CITY OF
West Linn
 PLANNING AND DEVELOPMENT

**STAFF REPORT
 PLANNING MANAGER DECISION**

FILE NO.: DR-18-09

REQUEST: Class I Design Review – Modify window configurations, as approved in March 2017 (DR-17-01), west building elevations and a variance for siding material

Wood Siding – Blistering/Peeling – 1914 Building

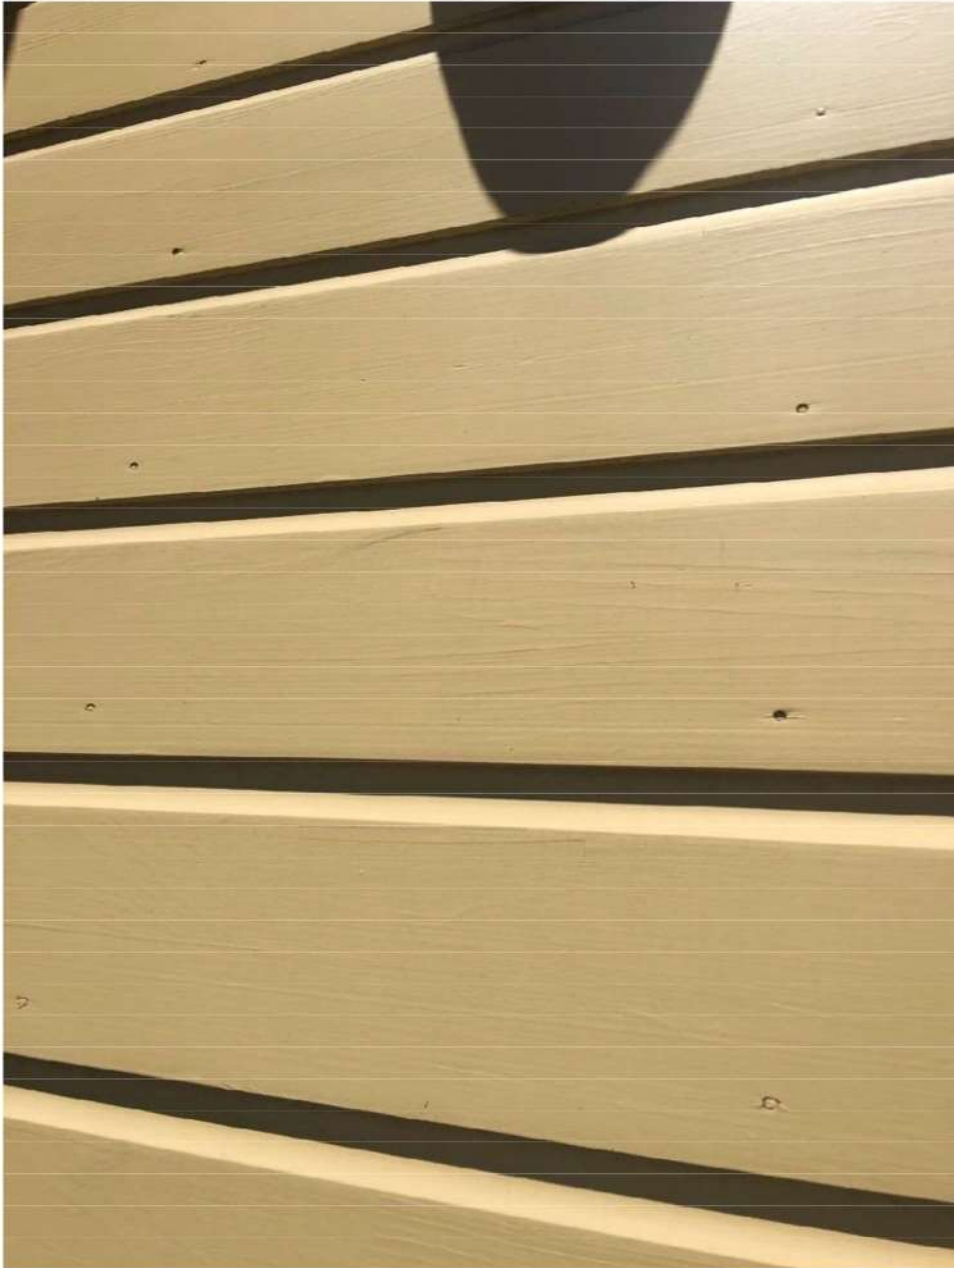
Siding: In the original HRB application, the applicant proposed wood siding in response to the requirements of the Standard, and after reviewing the results of the Icon building at 1969 Willamette Falls Drive. After reviewing the results of Icon's recent revision to their HRB application, the applicant is requesting a variance to CDC 58.090 to replace wood siding with Hardie-Plank fiber cement siding and trim on the main body of the building.

The applicant is now requesting an additional variance to allow the use of Hardie-Plank siding in place of previously approved wood siding. Please see Exhibit PD-4 for more details. The applicant has proposed the variance is incorporating exceptional 1880-1915 architecture into the building, including superior design, detail, and workmanship. The Historic Review Board recommended approval of the variance at its March 19, 2019 public hearing. Staff incorporates the applicant's findings. Subject to approval of the variance, this criterion is met.

WEST ELEVATION - PROPOSED REVISED HRB SUBMITTAL

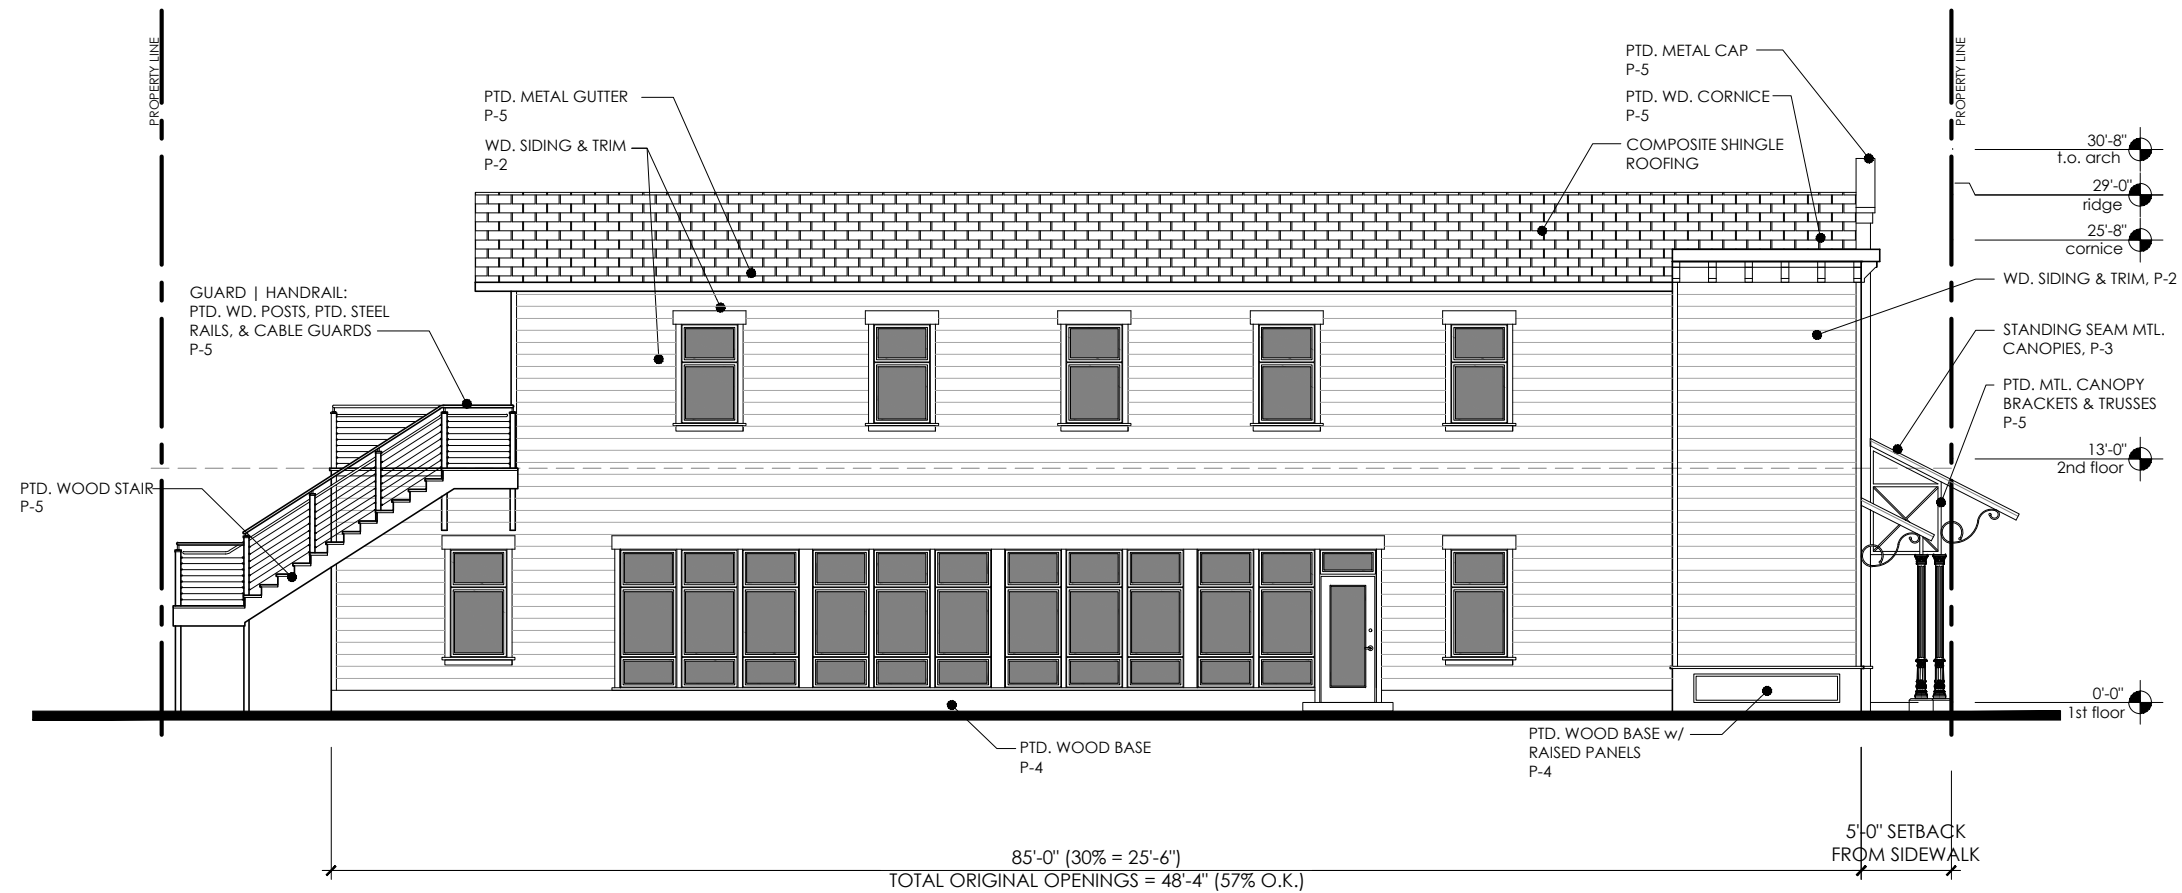
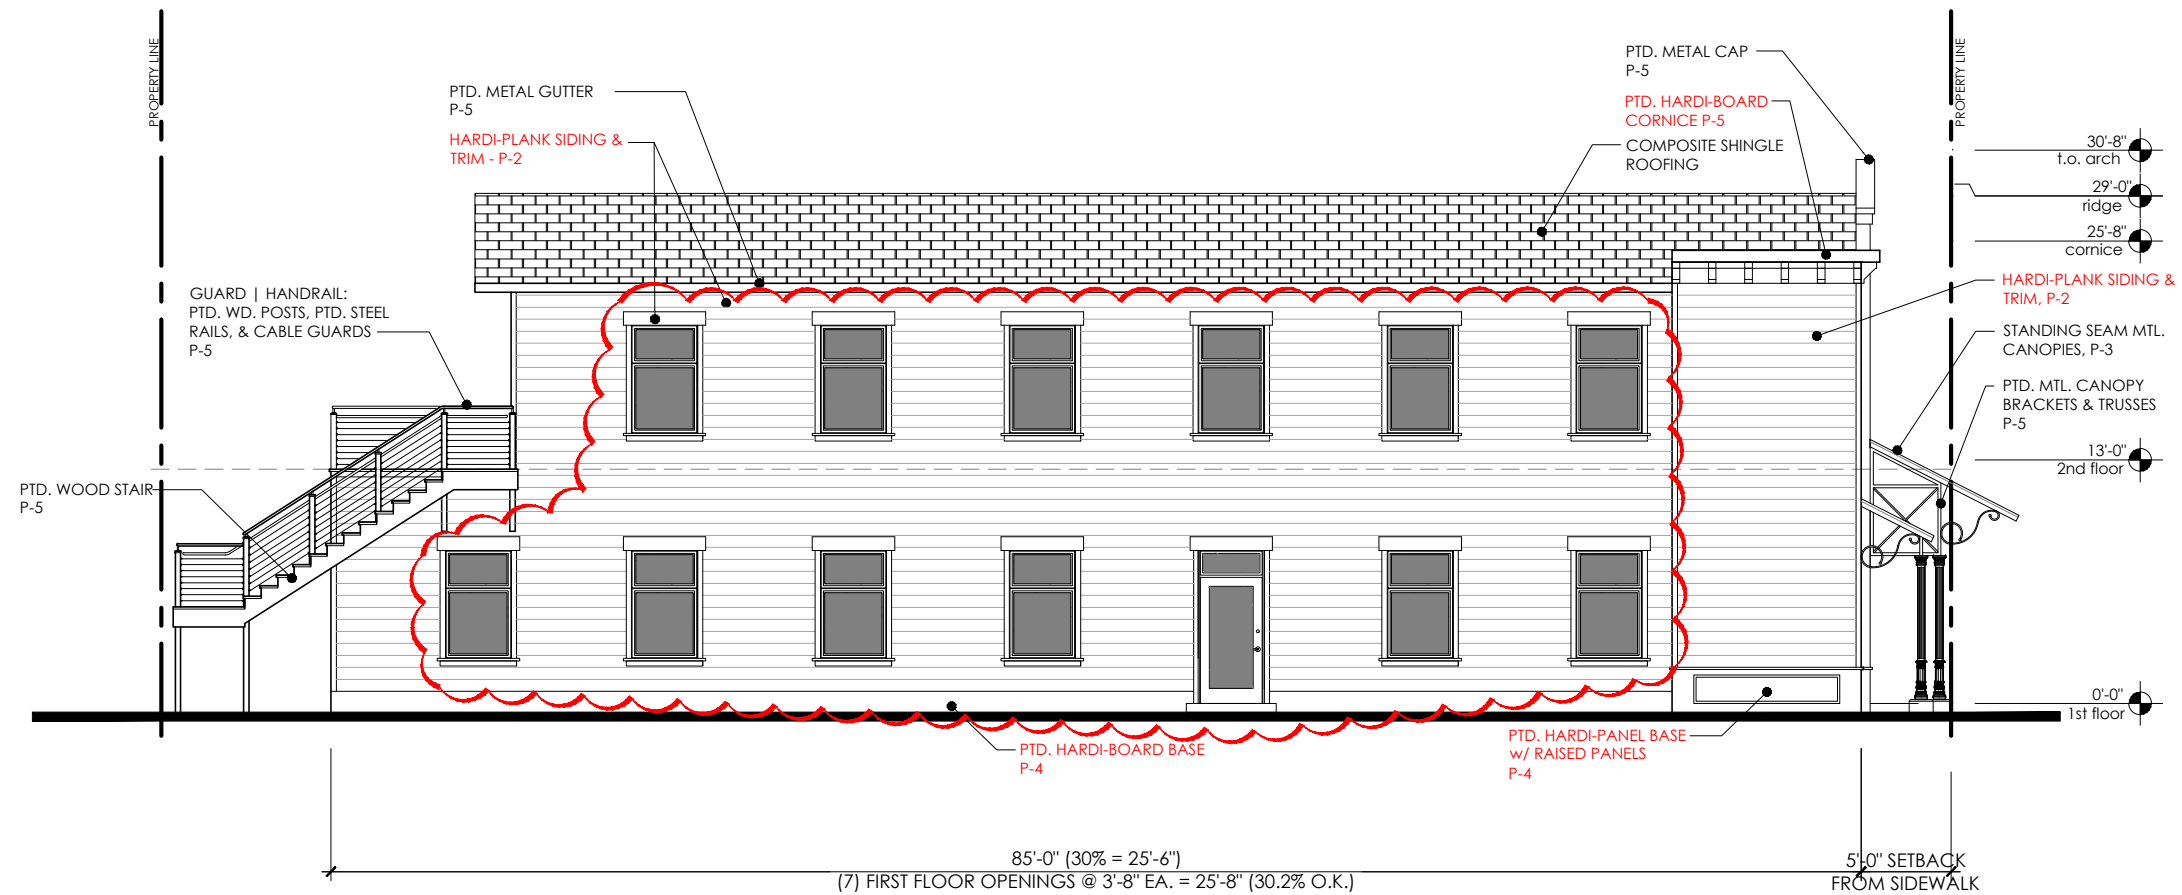
PROPOSED REVISION (TYPE 1 REVIEW): Per this proposed alteration, the windows on the west elevation will be revised from a single large opening flanked by 2 smaller windows to six evenly spaced windows and a glass man door. The new layout will result in 25'-8" of opening in an 85'-0" of elevation for a total of 30.2%. With this proposed change, the percentage of opening requirement for the side elevation is still met.

Staff Finding 7: The applicant is proposing to modify the windows on the west side elevation. There are not proposed changes to the south (front) elevation windows. The west elevation (side of building) proposal replace a large bank of windows with 3:1 ratio windows matching the south (front) elevation windows. All proposed windows are double-hung and have a minimum of two lights. This criterion is met.

WEST ELEVATION - PROPOSED REVISED HRB SUBMITTAL

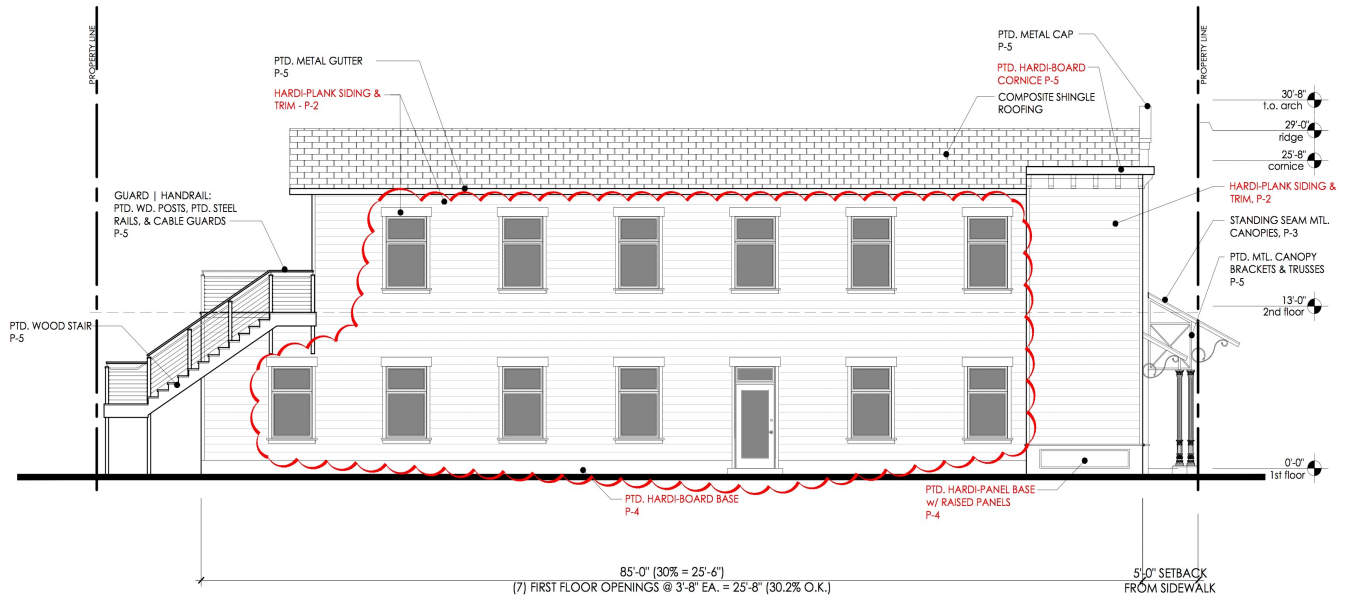
Prior Approved West (Side) Elevation
